भारत सरकार  
Government of India  
विद्युत मंत्रालय  
Ministry of Power  
उत्तर क्षेत्रीय विद्युत समिति  
Northern Regional Power Committee

**विषय:** संरक्षण उप-समिति की 45<sup>वीं</sup> बैठक के कार्यवृत्त।  
**Subject:** Minutes of 45<sup>th</sup> Protection Sub-Committee Meeting.

## ***Minutes of 45<sup>th</sup> Meeting of Protection Sub-committee***

# Observations

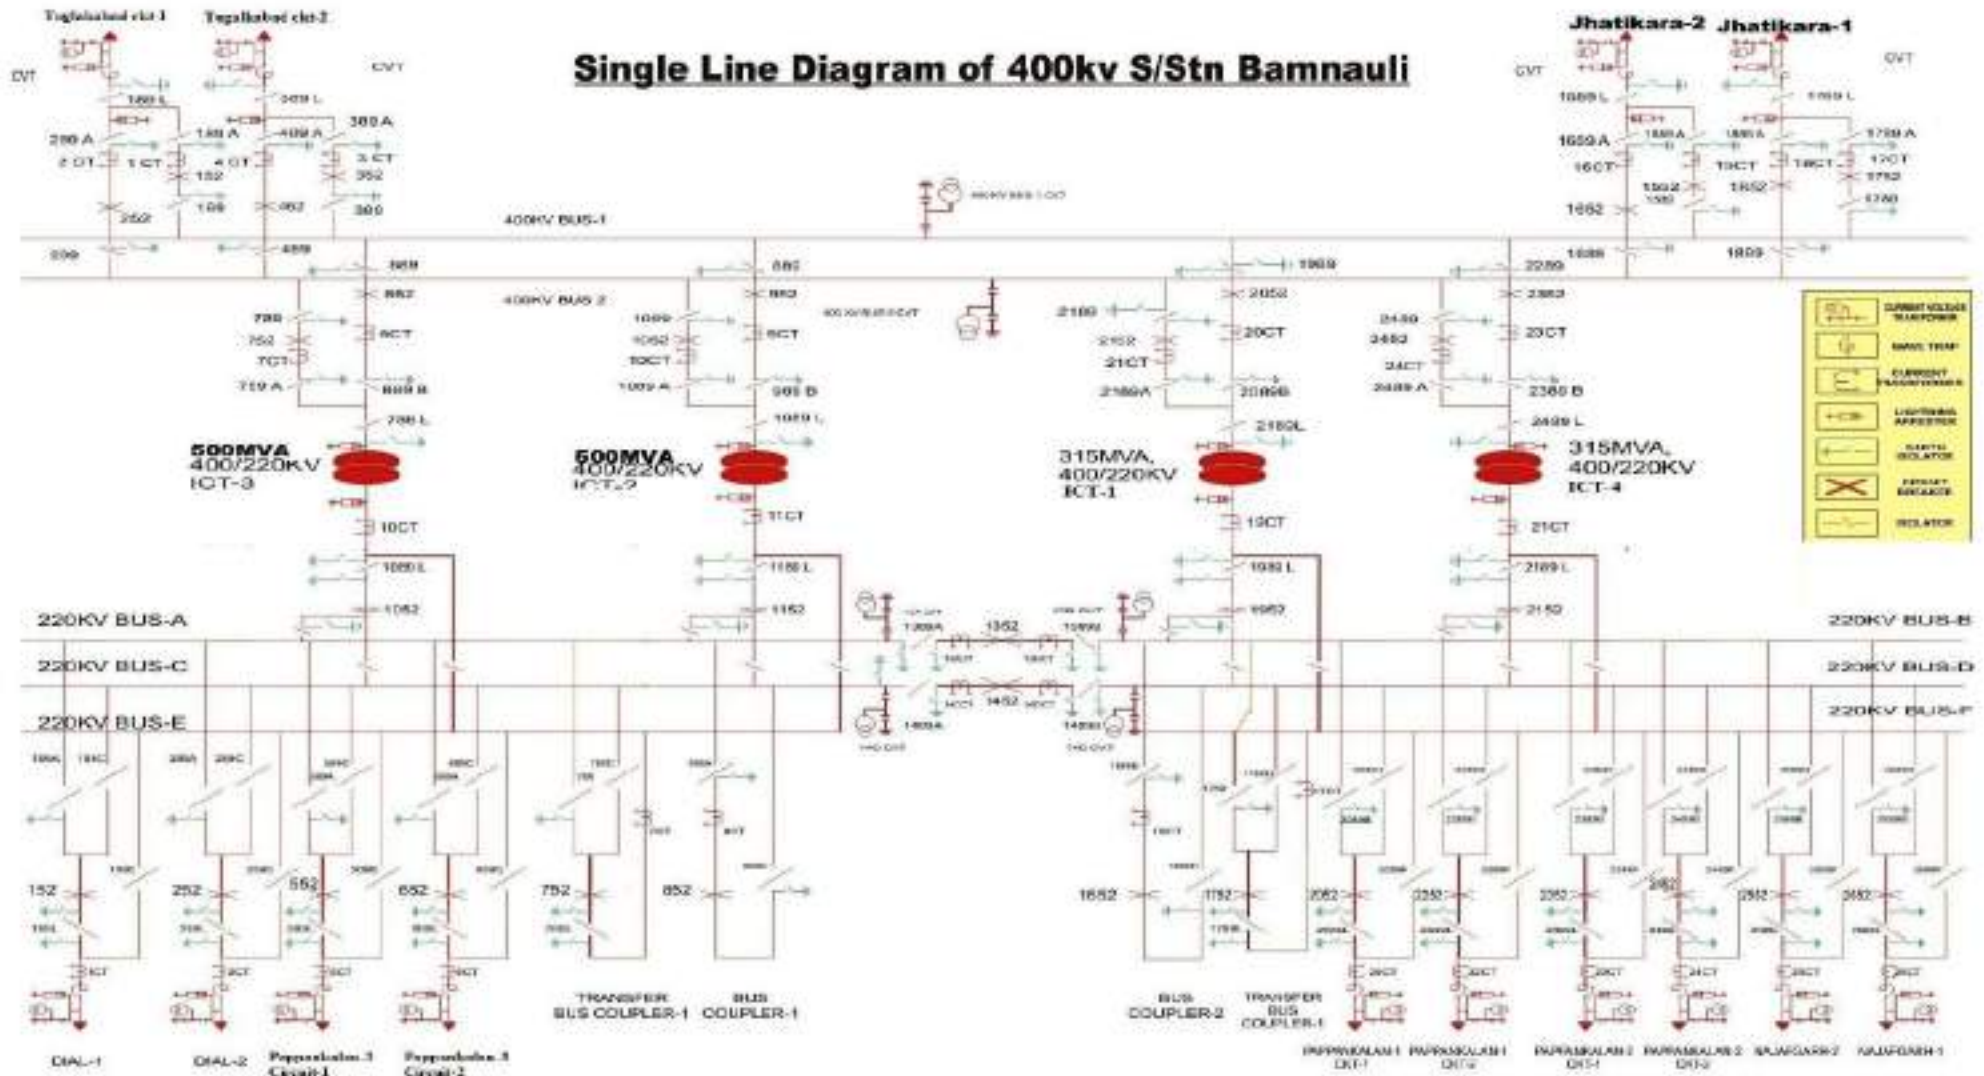
1. Reason of delayed clearance of fault?
2. Why did 220kV Bamnauli-DIAL-1 & DIAL-2 tripped before 400/220 kV 315 MVA ICT 1 at Bamnoli(DV)?(as per SOE obtained at NRLDC)
3. Exact sequence of tripping of elements and detailed tripping report needs to be shared with remedial action taken.

# DR of Dhauliganga-Pithoragarh (Dhauliganga end)

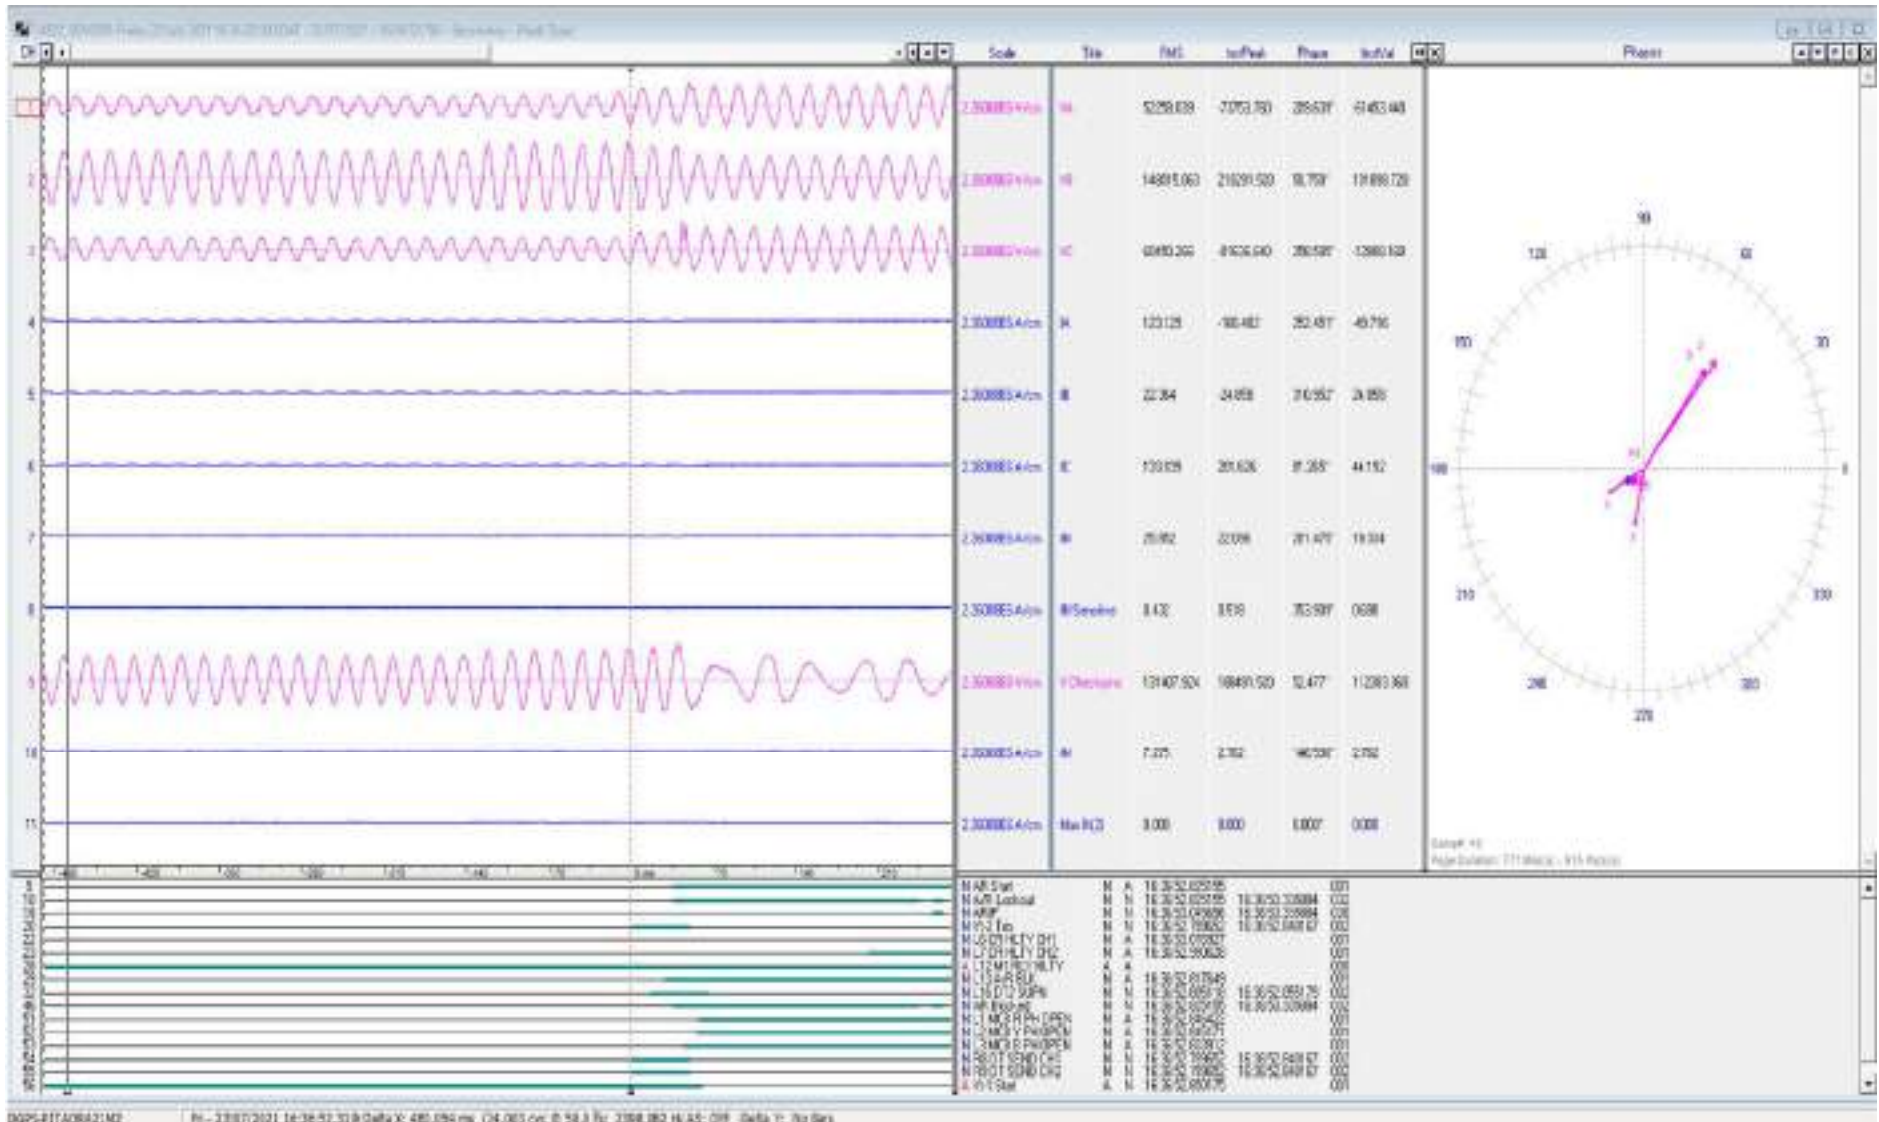
Line tripped within 50ms of OV stage-2 start, time delay setting of OV protection at Dhauliganga NHPC needs to be reviewed.

# DR of 220kV Singoli Bhatwari-Srinagar ckt (Singoli end)

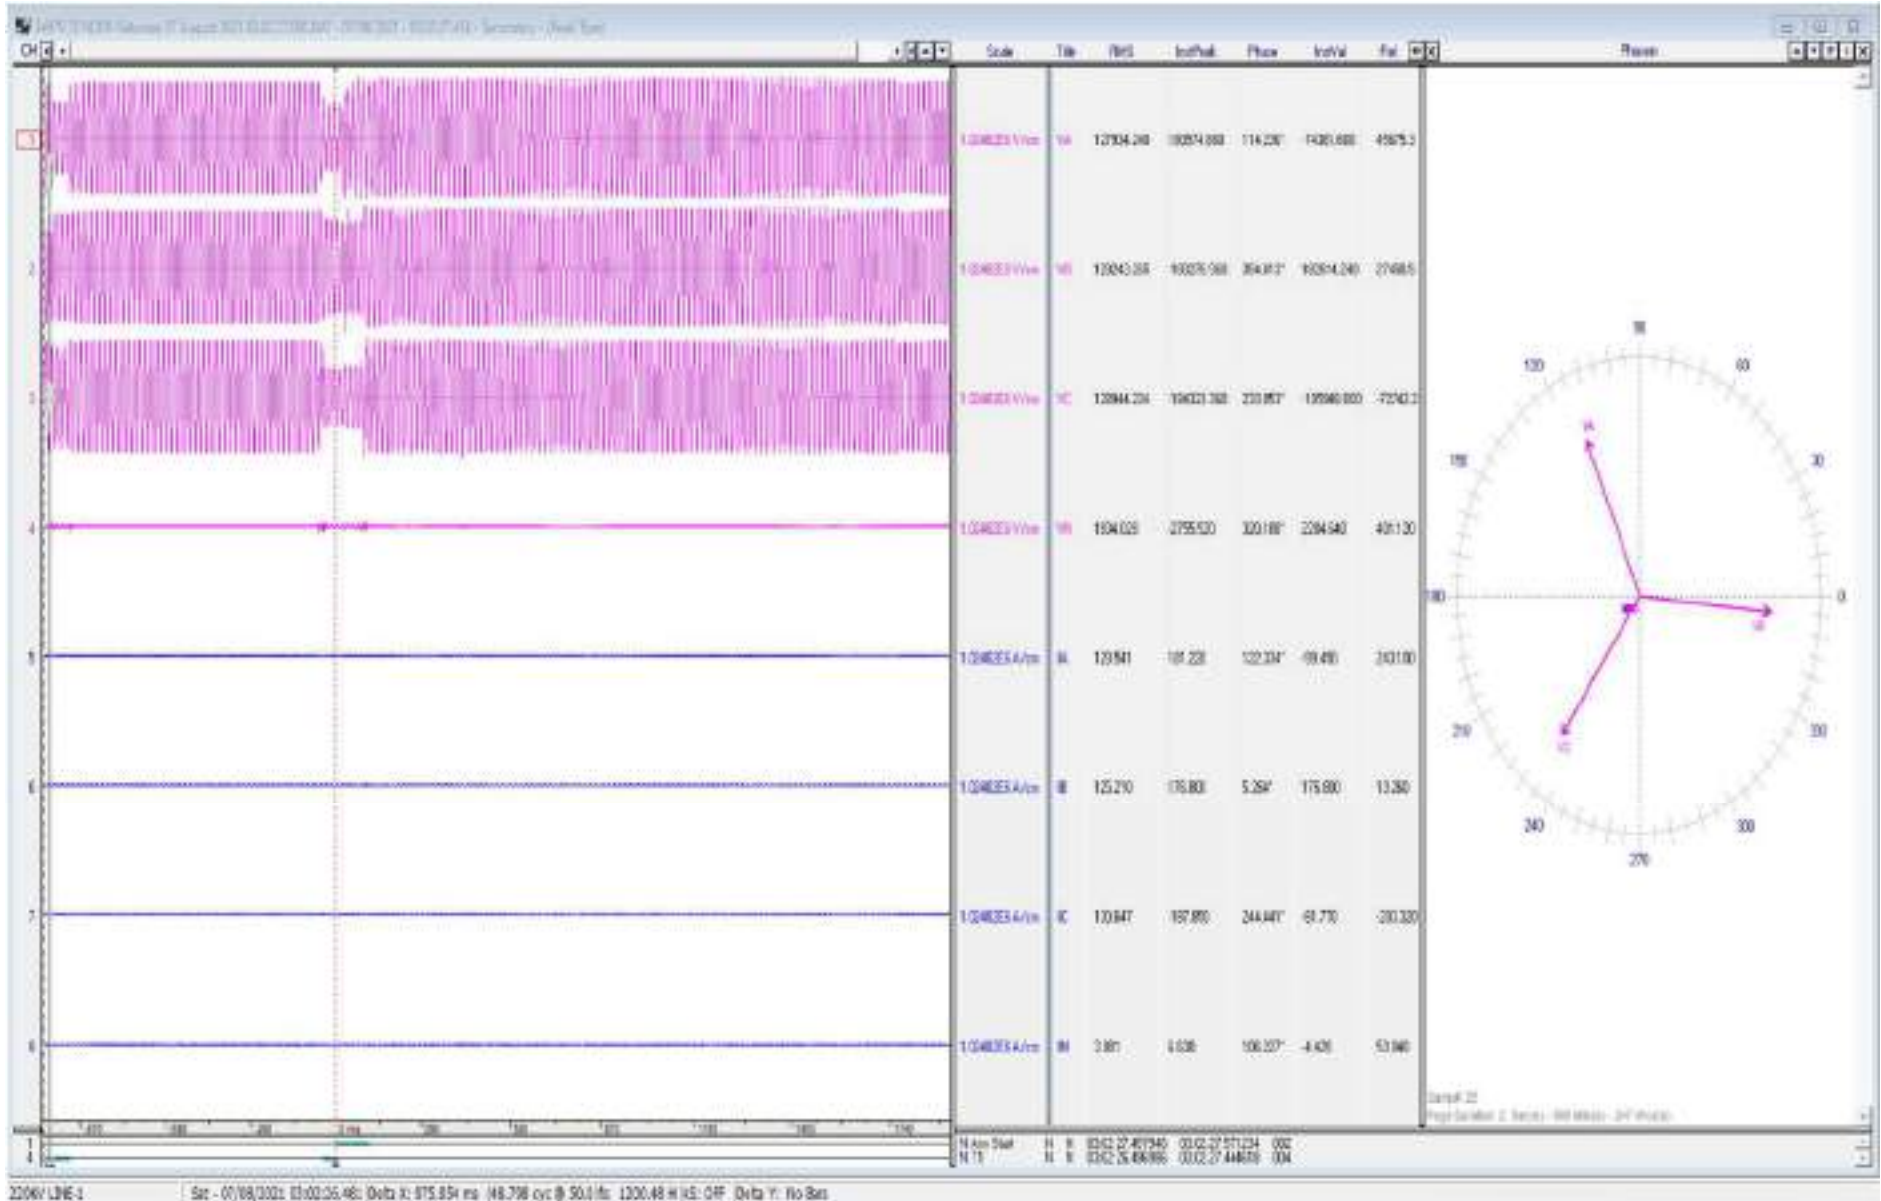
Which protection had initiated the tripping? Not recorded in DR

# DR of 400kV Muzaffarnagar-Meerut ckt (Meerut end)

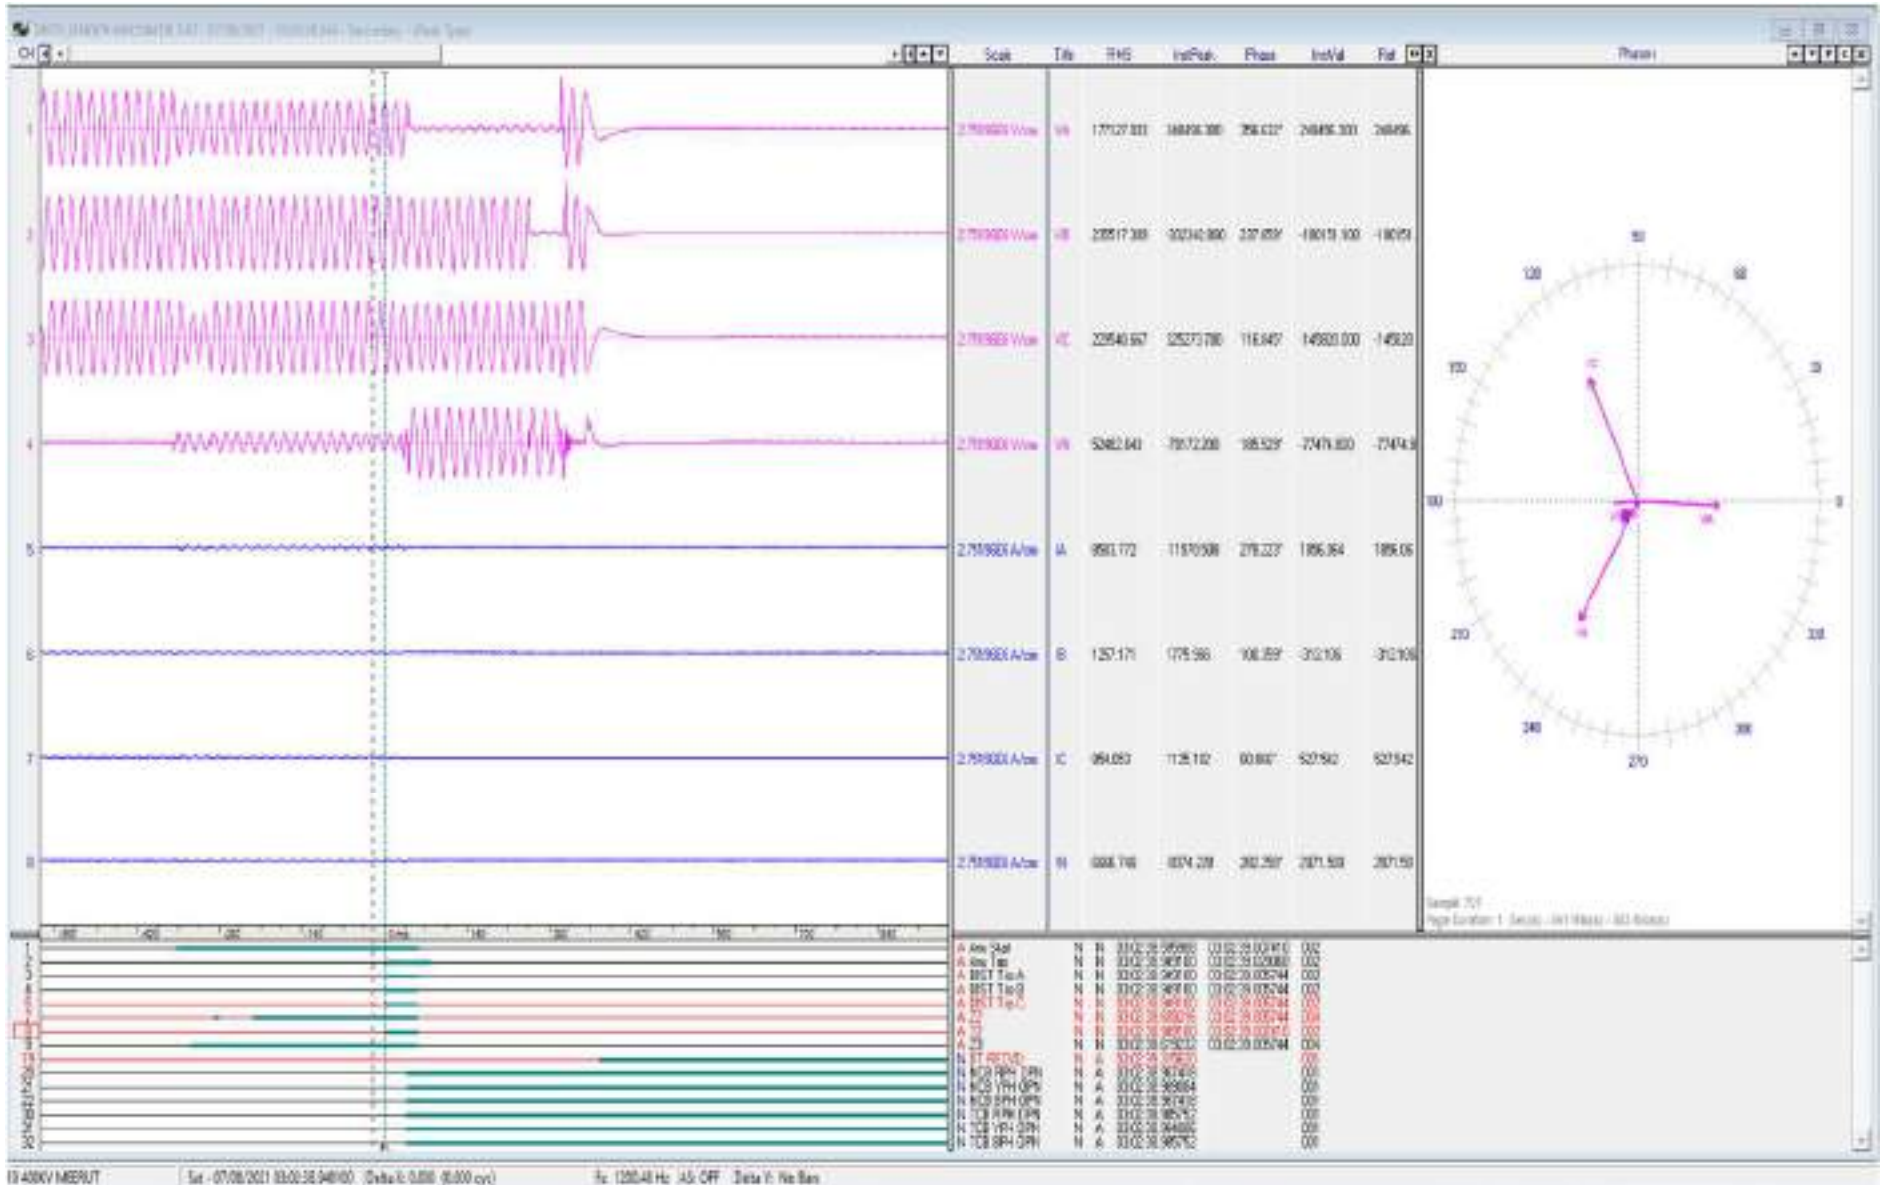
Line tripped in Z-2 from Meerut end after 300ms

# DR of 400kV Muzaffarnagar-Alkanda ckt (Alkanda end)

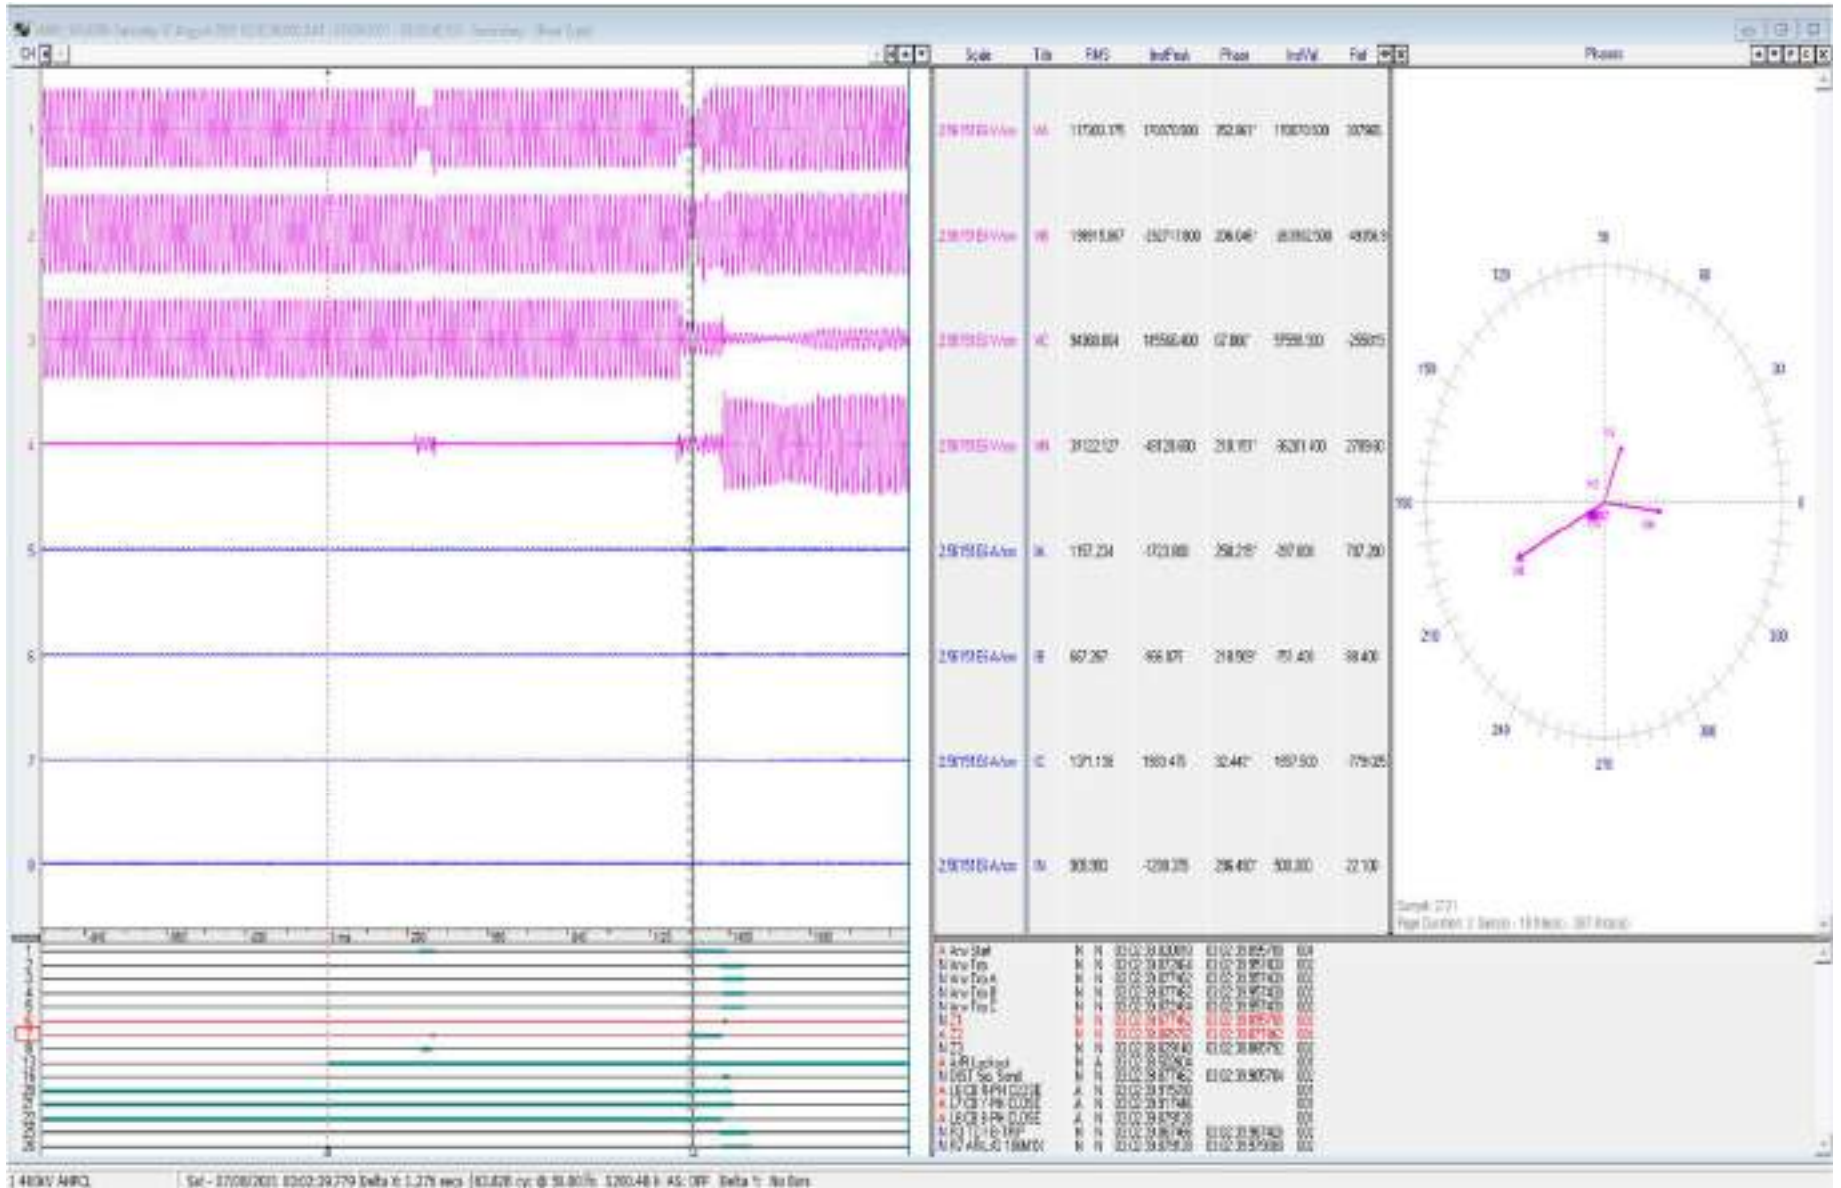
Fault was in Z-2 from Alaknanda end
